Subject: Final Rule, Response to Petitions for Reconsideration, Technical Amendment, Docket No. 2008-0111, Anthropomorphic Test Devices; ES-2re Side Impact Crash Test Dummy 50th Percentile Adult Male.

First Technology Safety Systems (FTSS) has reviewed the February, 2008, ES-2re dummy drawing package (identified in the above mentioned technical amendment) and we have identified a number of drawing errors and a number of drawing issues. We seek to petition NHTSA to correct these drawings to ensure that the ES-2re dummy continues to meet the same dimensional and performance requirements established for the dummy when the dummy was proposed for inclusion into 49 CFR Part 572 Subpart U. FTSS makes the following comments and recommendations with respect to the drawing package. A marked up drawing for each of these recommended changes are attached to the end of this letter.

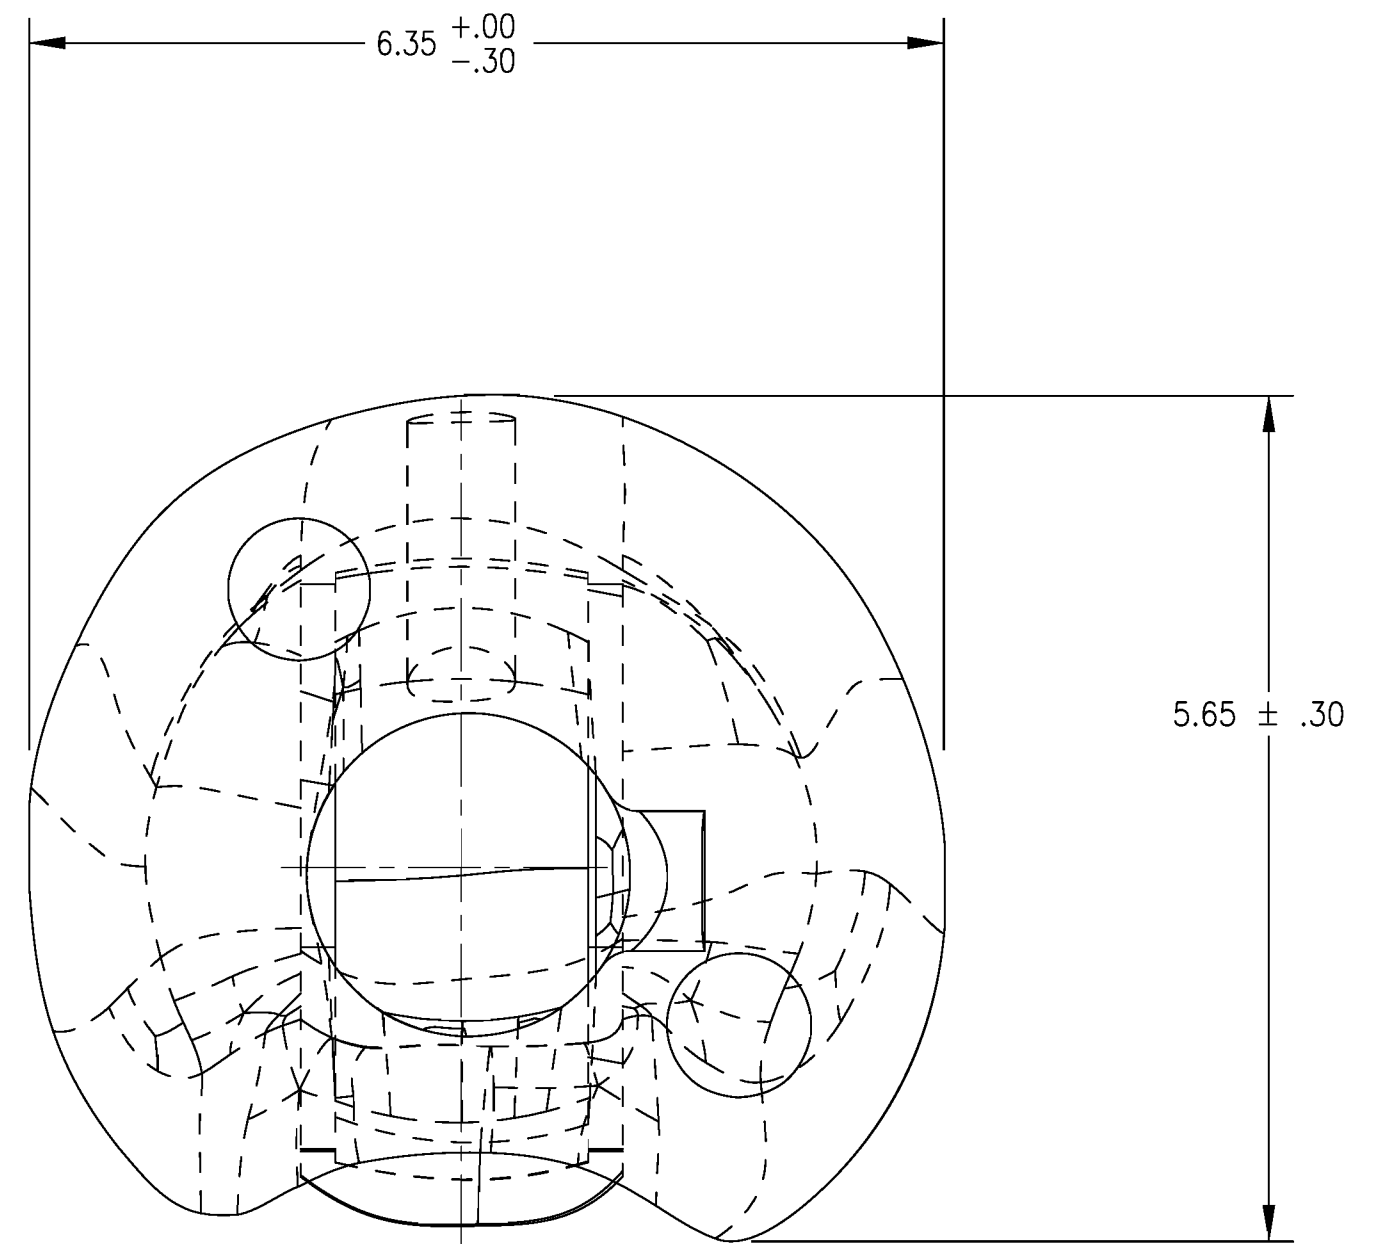
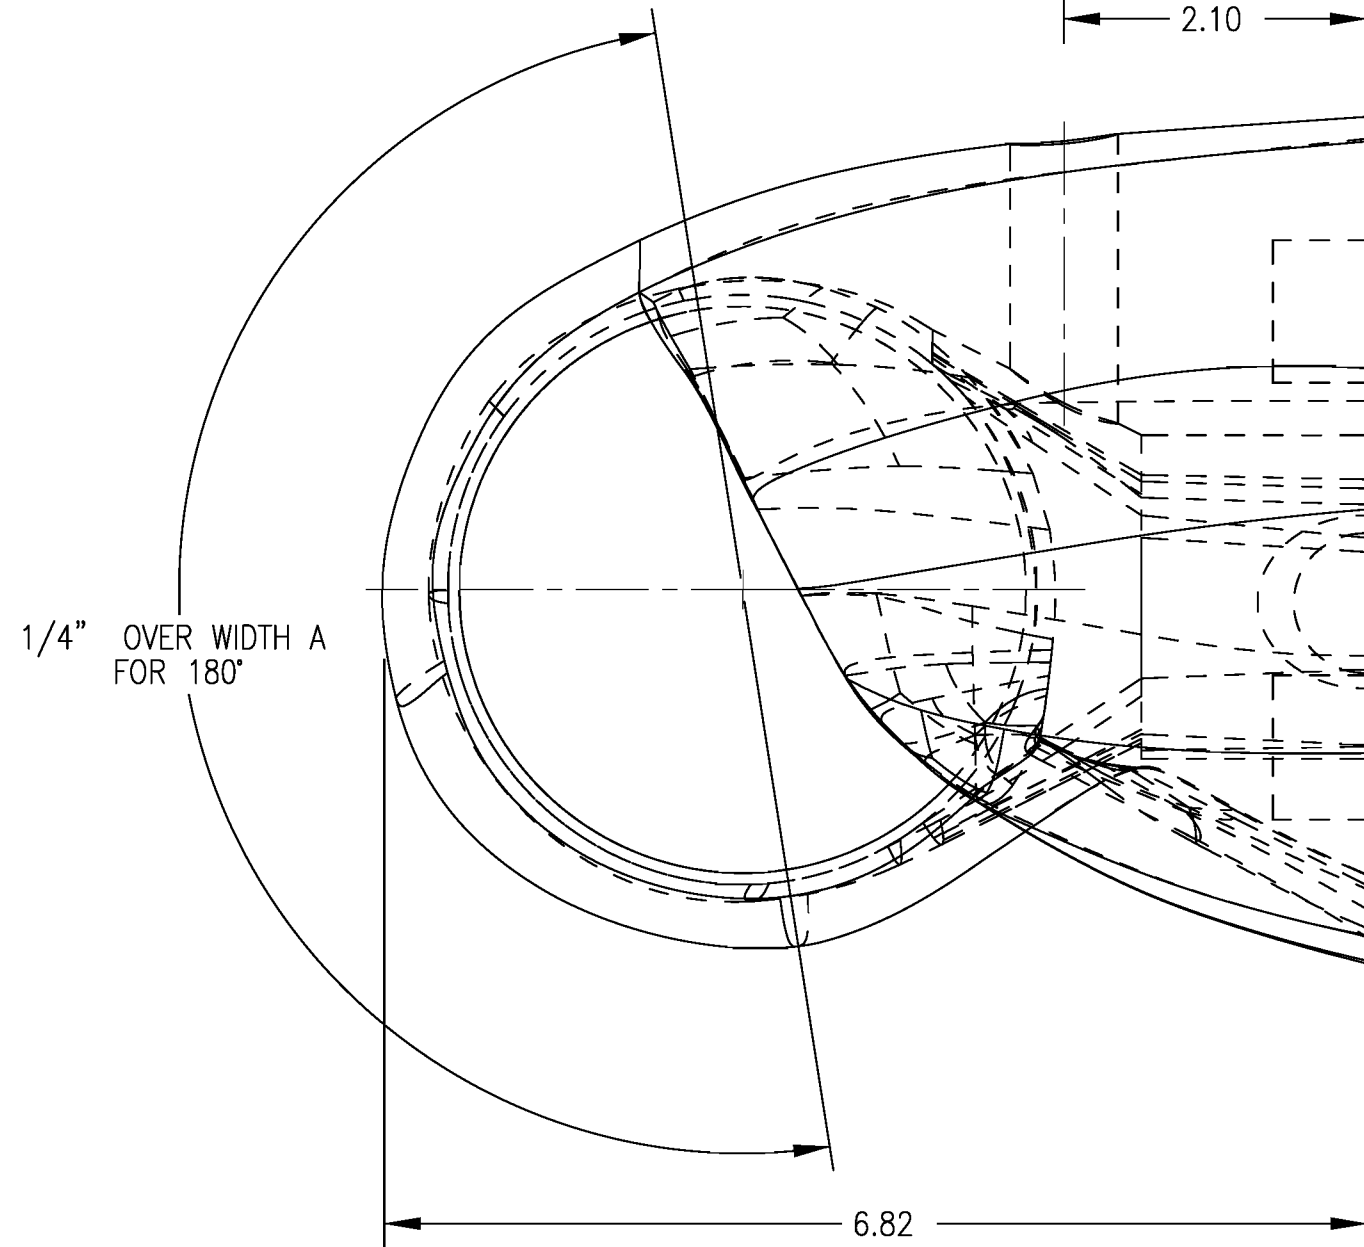
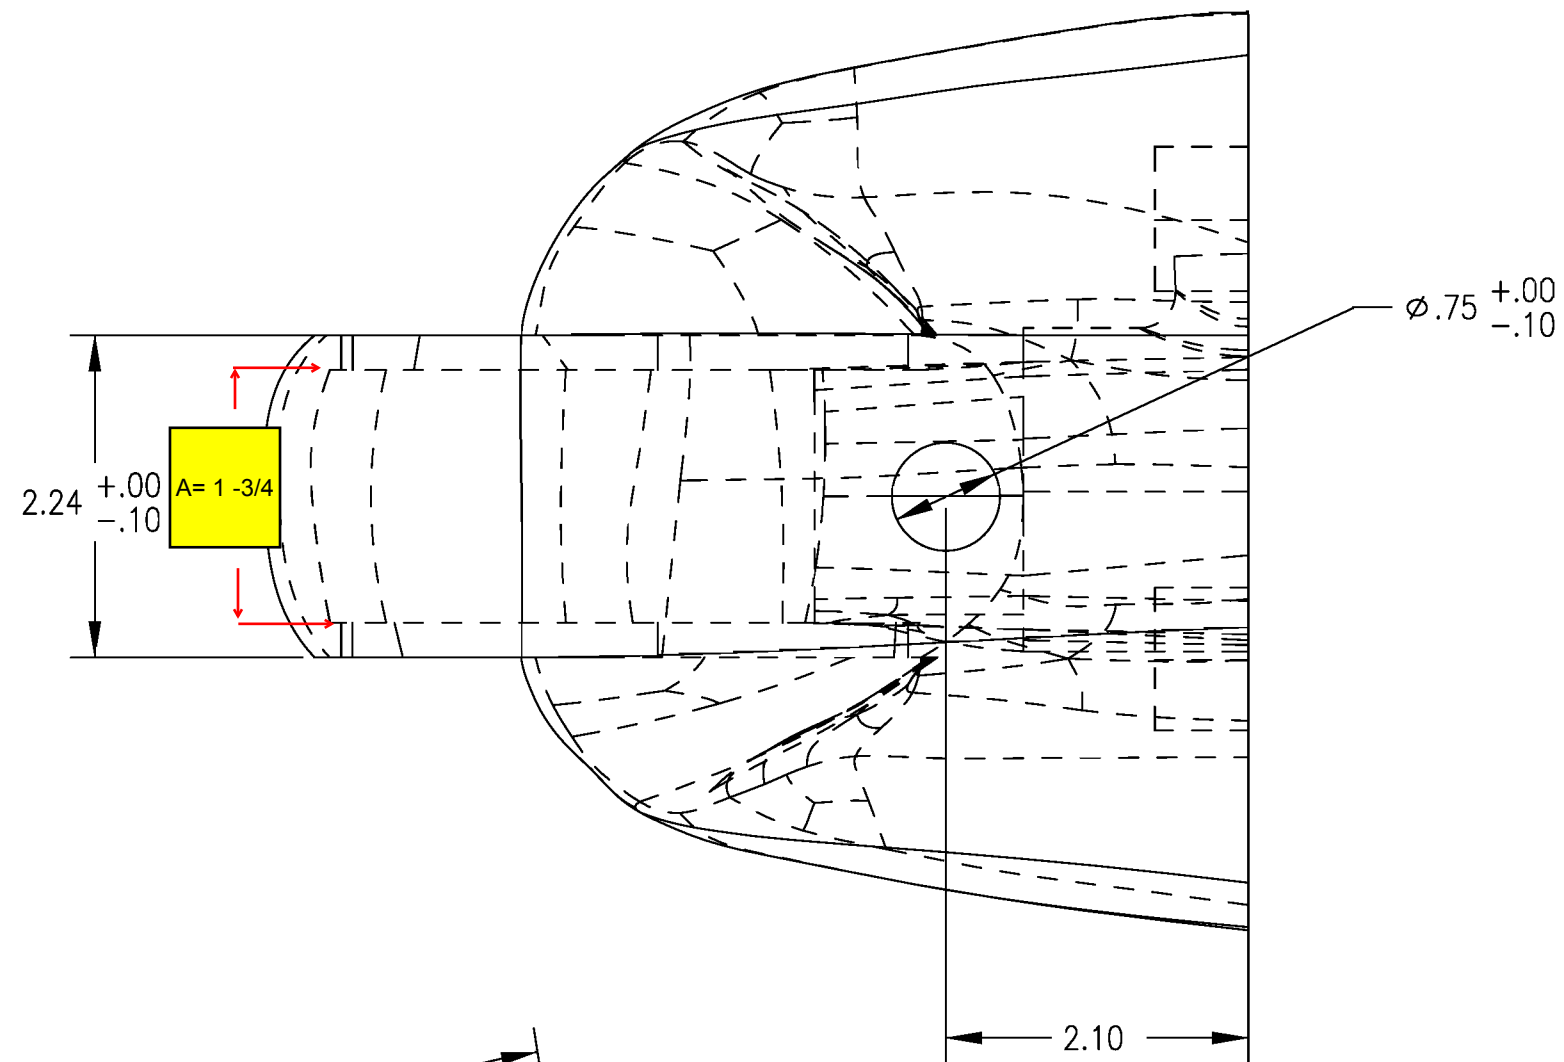
- 13) Drawing 175-7085-1, Knee Flesh, Left. There is a note on the drawing that states: $\frac{1}{4}$ " OVER WIDTH "A" FOR 180° . But, "A" is not defined on the drawing. However, "A" is defined on the corresponding drawing 175-7085-2, Knee Flesh, Right. FTSS recommends that drawing 175-7085-1 be corrected to add a definition for "A" to match drawing 175-7085-2 – which specifies that $A = 1 - \frac{3}{4}$ ".

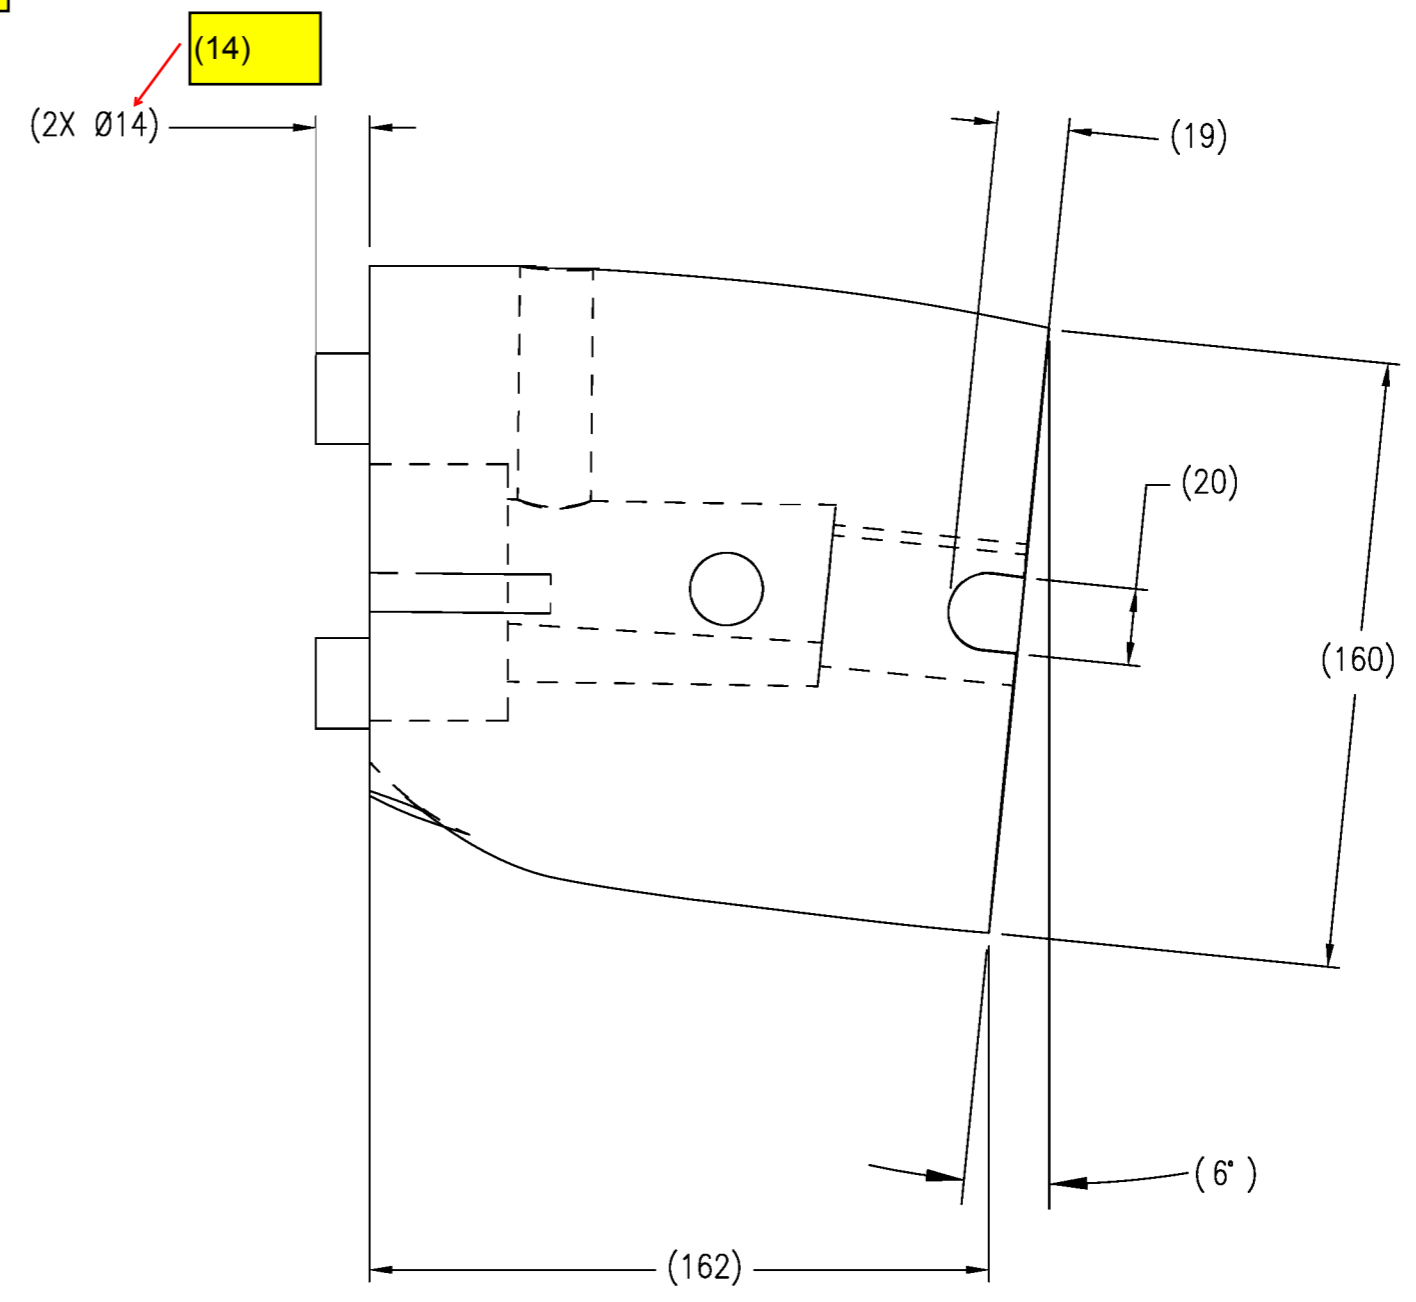
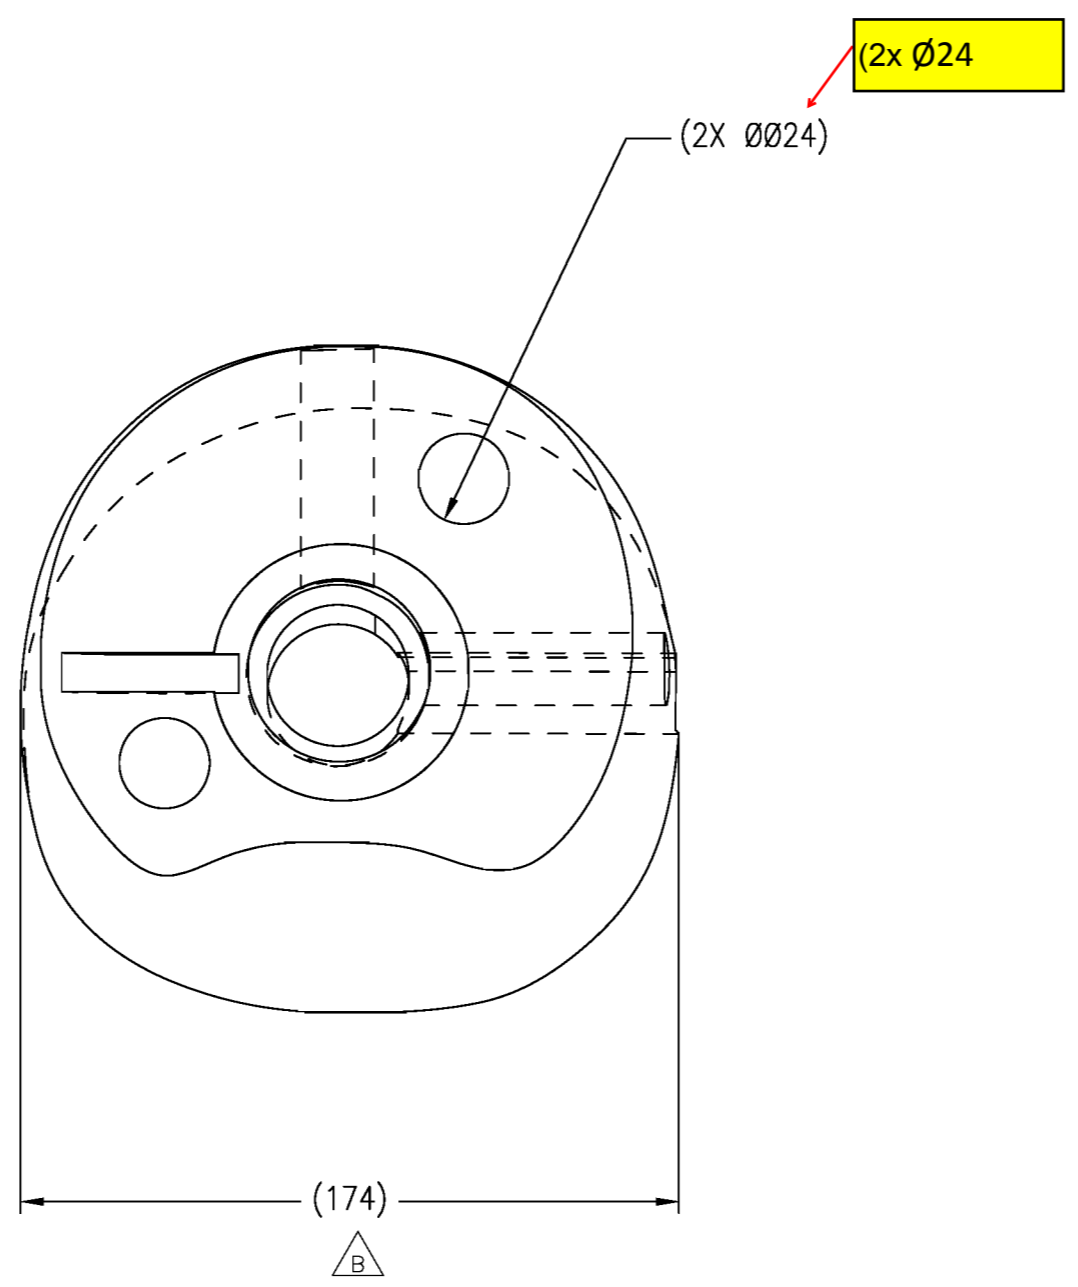
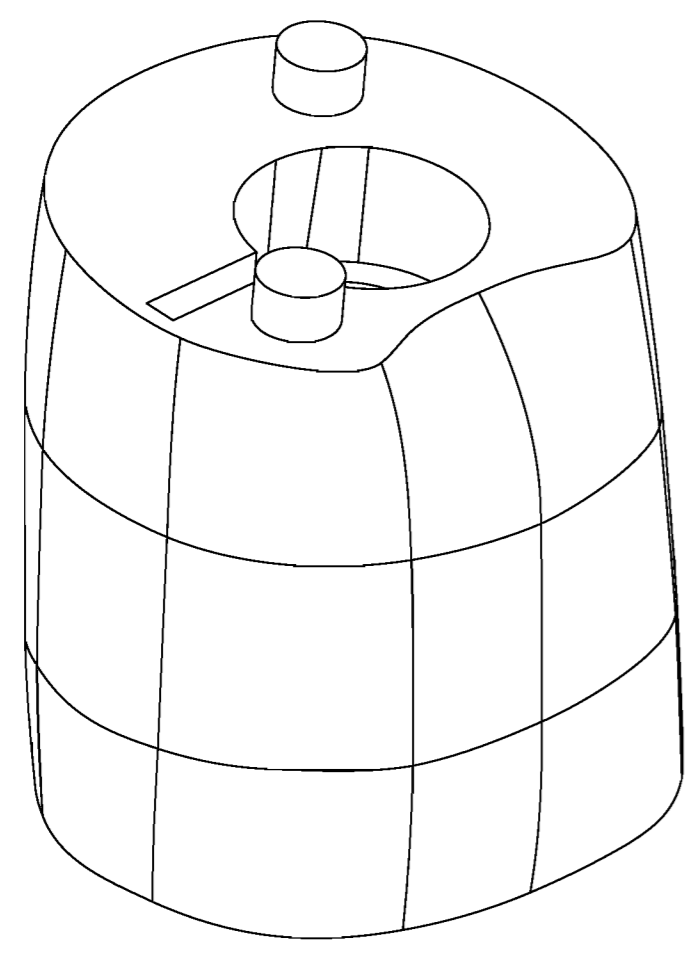
- 14) Drawing 175-7090-1, Thigh Molded, Left. Fix typographical errors for drawing dimensions $(2x \text{Ø}24)$ " and $(2x \text{Ø}14)$ ". These dimensions should be listed as $(2x \text{Ø}24)$ " and $(2x14)$ ". Removal of extra or redundant Ø symbol is required. This would also make this part consistent with the Thigh Molded, Right drawing (NHTSA Drawing 175-7090-2).

ITEM NO.	QTY	PART NO.	DESCRIPTION
PART LIST			
UNITS ARE millimeters			 NATIONAL HIGHWAY TRAFFIC SAFETY ADMINISTRATION
MATERIAL REF. BRONZE			
SCALE 3.000			BEARING
APPROVALS		DATE	
DRAWN		CHECKED	SIZE A3 SHEET 1 OF 1 DRAWING NUMBER 175-9013
ENGINEER		REV. B

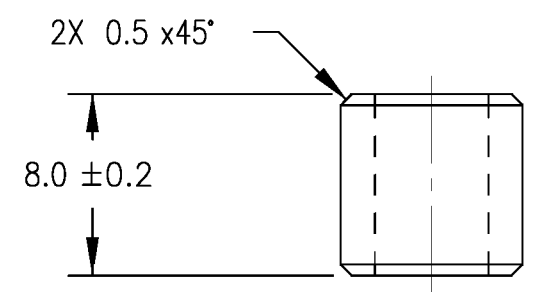
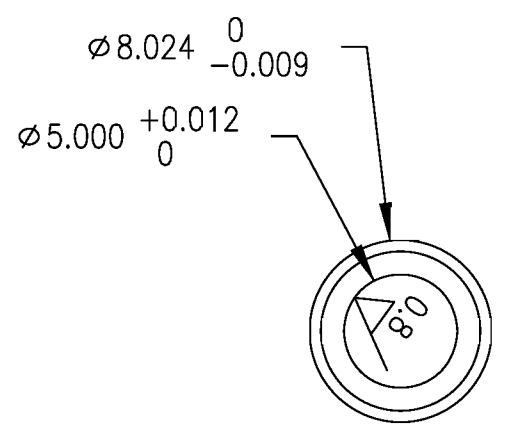
- 15) Drawing 175-9013, Bearing. The drawing has a reference to Note#2 in the revision record (REV B), but the note is missing from the "NOTES" field. FTSS recommends that the note be added to the note field, or the note reference be eliminated from the revision record.

No Note #2

ITEM NO.	QTY	PART NO.	DESCRIPTION
PART LIST			
UNITS ARE millimeters			 NATIONAL HIGHWAY TRAFFIC SAFETY ADMINISTRATION
MATERIAL REF. SS 304			
SCALE 3.000			PIN, MACHINED
APPROVALS		DATE	
DRAWN			
CHECKED			
ENGINEER			
SIZE	SHEET	DRAWING NUMBER	REV.
A3	1 OF 1	175-9014	B

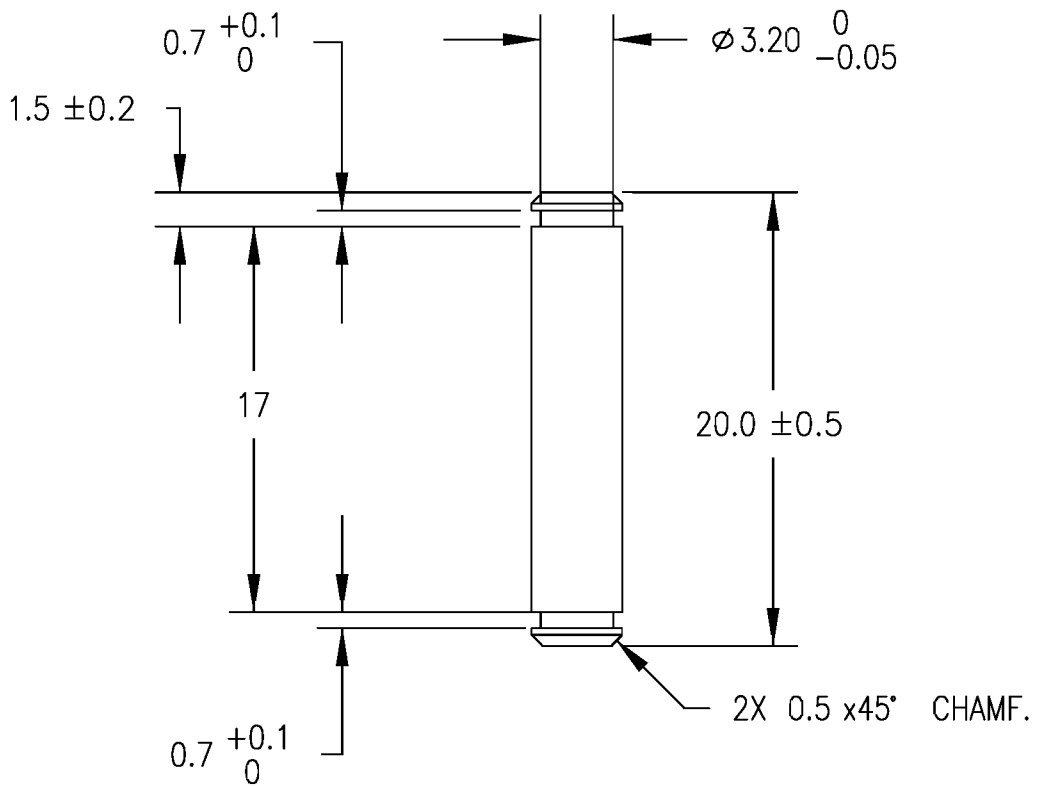
- 16) Drawing 175-9014, Pin Machined. Correct typographical error for missing revision indicator for REV B on the Material Reference. The revision record states "ADDED REF. TO MATERIAL SPECIFICATION"; however no revision reference bubble was added.

No rev Indicator
